MINUTES
DETROIT HISTORIC DISTRICT COMMISSION REGULAR MEETING
August 12, 2026
Coleman A. Young Municipal Center, Suite 808

3418-3426 John R – HDC2026-00381 – Brush Park – ET – Demolish rear walls, erect addition, rehabilitate three units

3426,3422 and 3418 John R Facade

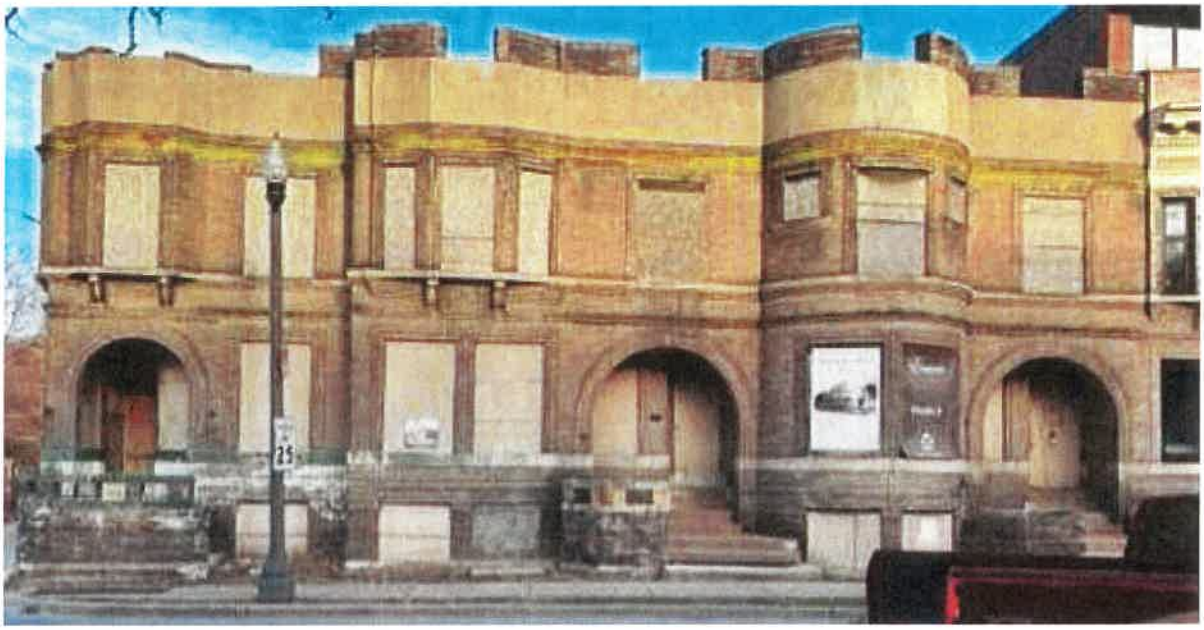
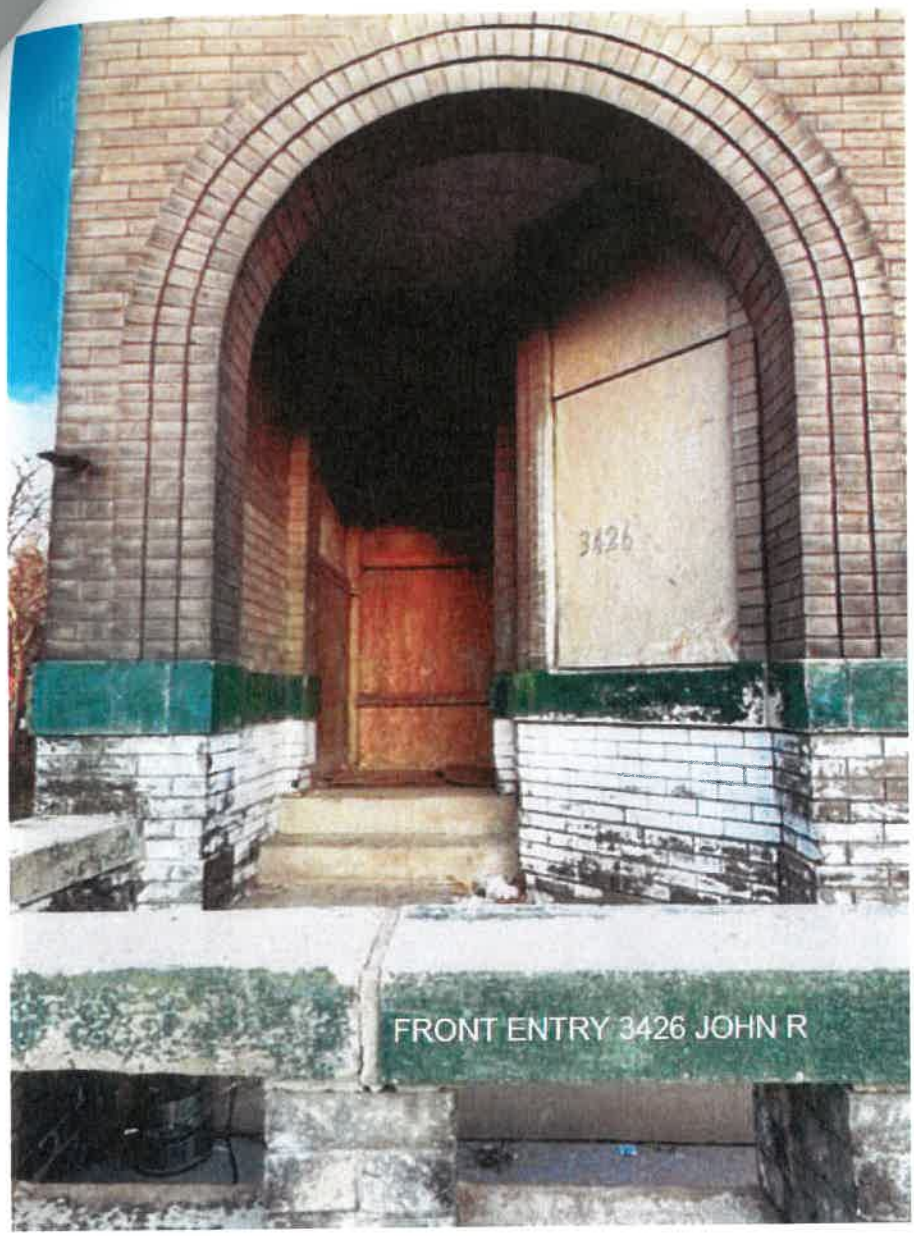
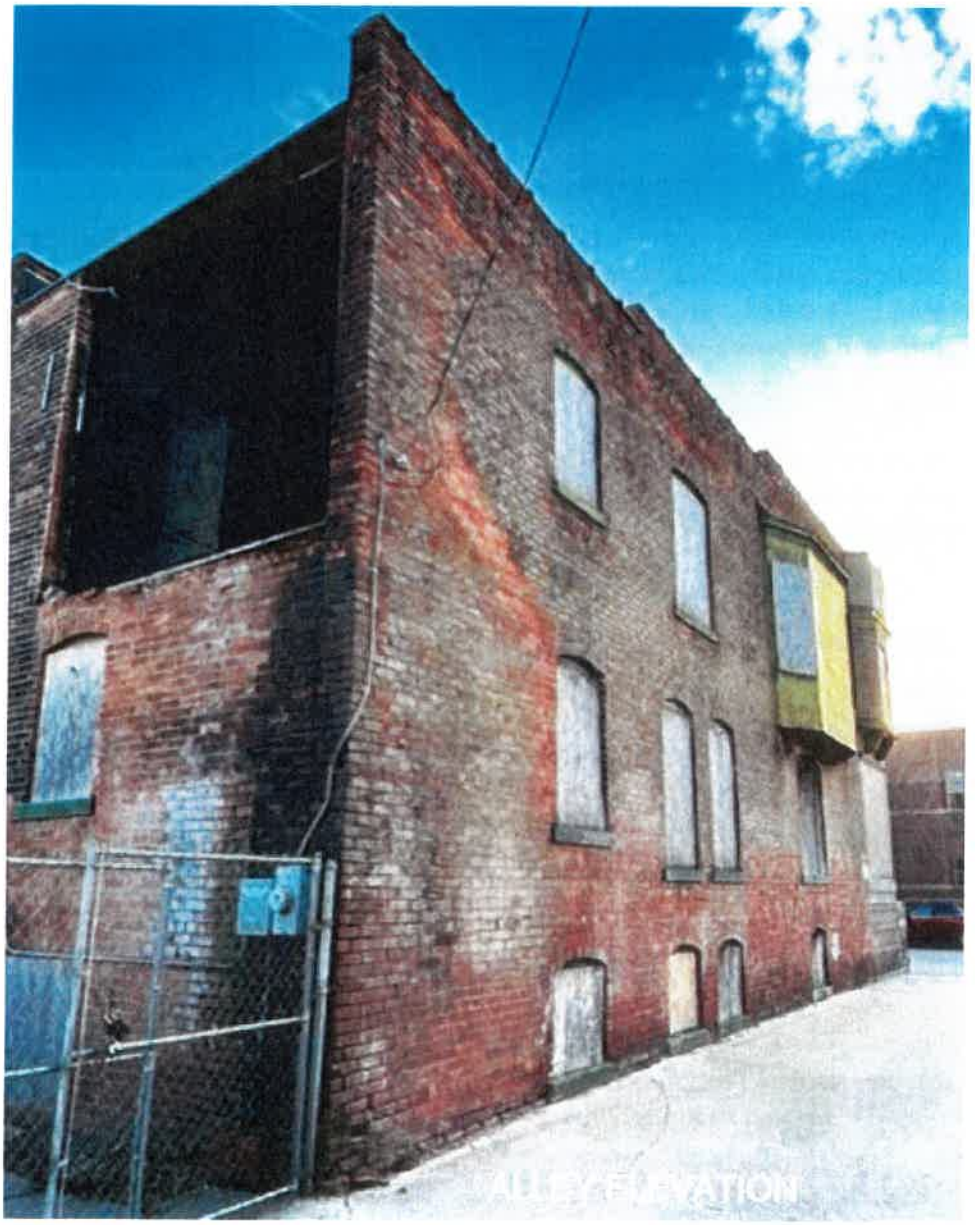
2. Where historic windows had a cottage-style configuration, that configuration and those proportions will be preserved in any replacements.
3. For masonry cleaning, the cleaning agent (if any), rinse specifications, and proposed pressure will be shared with staff for review and approval. Photos of proposed replacement bricks next to historic bricks will be provided for staff review and approval. Mortar composition, color, joints, and tooling will match historic.

The primary facade facing John R is in relatively good shape. Both brick and stone are dirty with small areas that have been painted. See material and specifications on the detergent and application below.

The secondary facades facing the alley and rear facade are dirtier than the primary facade. The red brick is softer than the beige brick, and care must be taken when pressure washing. Many of the limestone sills have been painted. See material and specifications on the detergent and application below.

1 A2-5 **PROPOSED ADDITION -EAST ELEVATION**

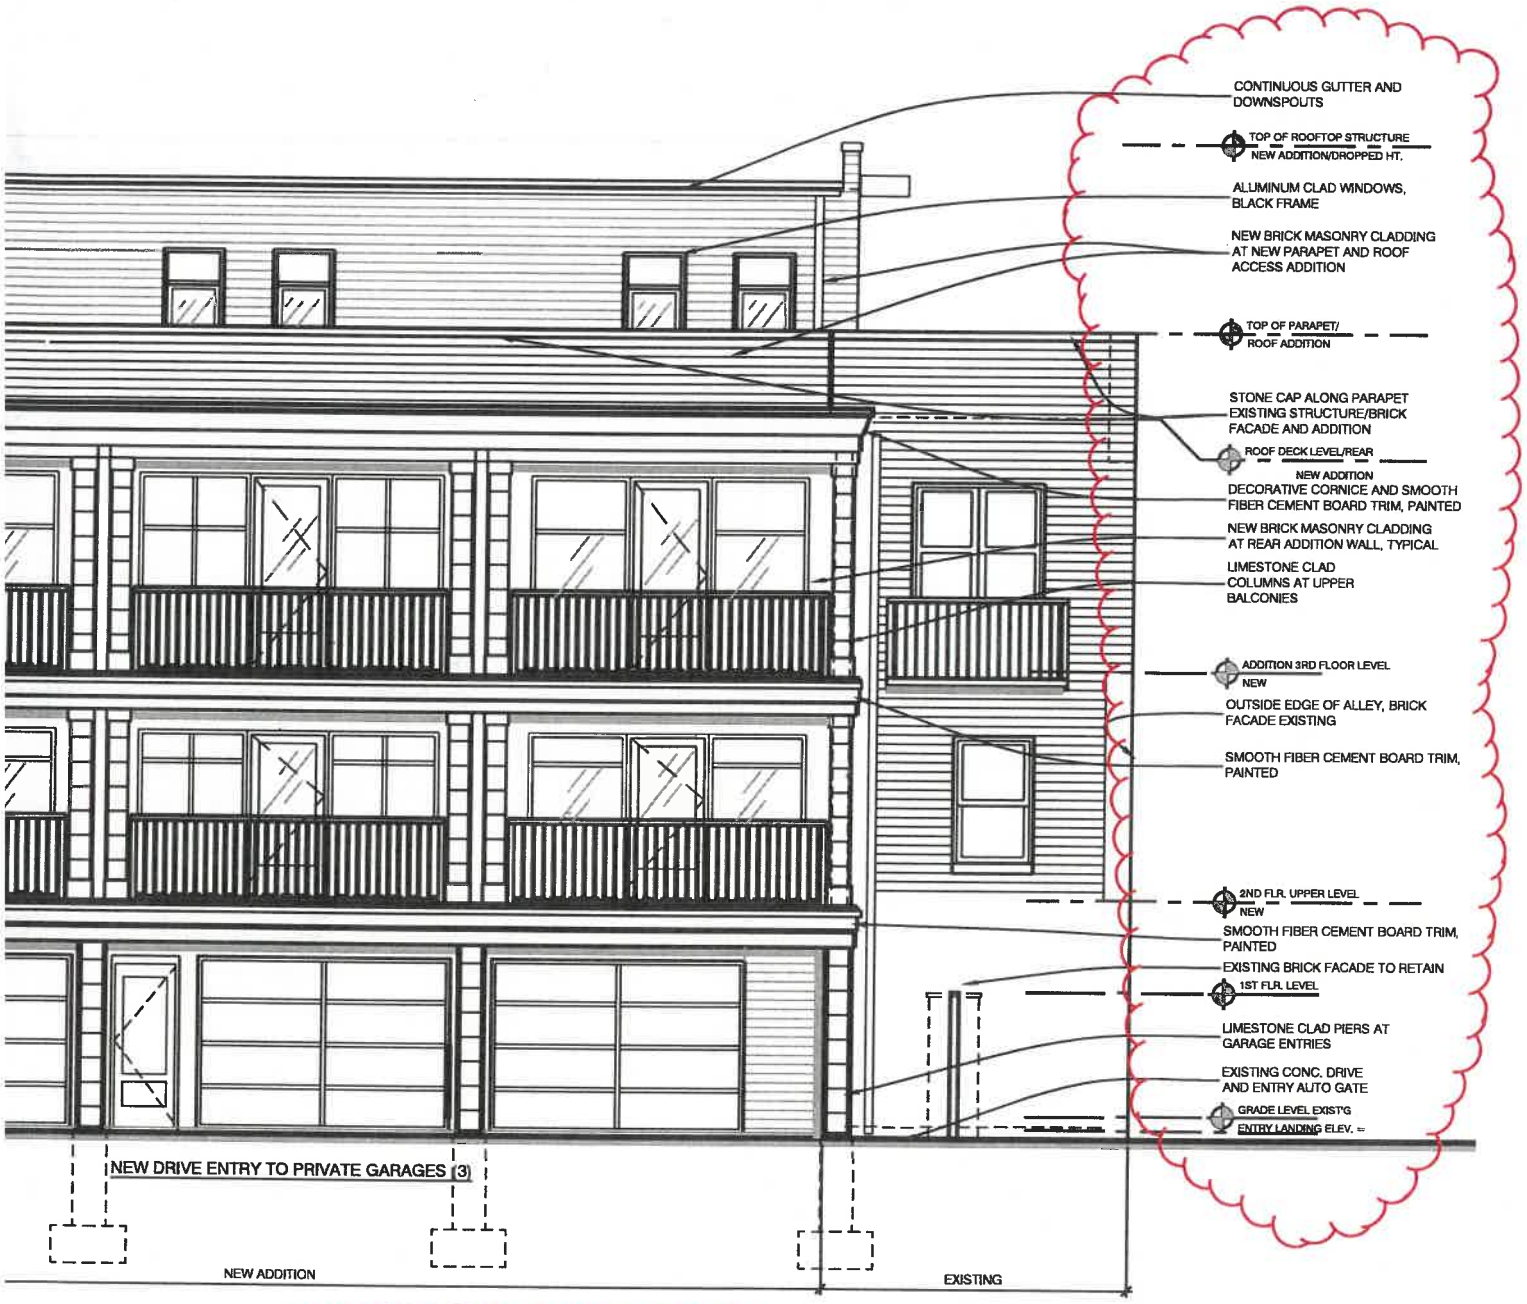
1. The applicant will propose an alternate cladding material and color to more closely reflect the district's Elements of Design and the nearby context in terms of architectural features, materials, and color; the applicant will revise the detailing at the parapet line of the rooftop addition to de-emphasize the addition's height; the applicant will propose simpler balcony posts (in a material other than polyurethane); and the applicant will propose a simpler balcony guardrail, all for staff review and approval, with the goal that the rear addition/rooftop addition will be simplified and more deferential to the historic primary facades.

1. The roof top addition has been lowered from 16'-7" to 14'-11". The rooftop addition will not be seen from the John R right-of-away.
2. We have removed the east parapet of the roof top addition and show gutter and downspouts.
3. We have replaced all the limestone wall veneers with brick veneers. The color was selected to contrast the original red brick. See the attached picture of the proposed brick.
4. We have replaced the balcony columns from a polyurethane cast column to square limestone columns.
5. We have removed the cornices from the top of the parapets.
6. We have removed all the cornices above the balconies except for the cornice above the third floor. The first and third floors will have simply built-up board trims.
7. The proposed aluminum balcony railings are simpler and not decorative. See the attached image of the proposed railing.
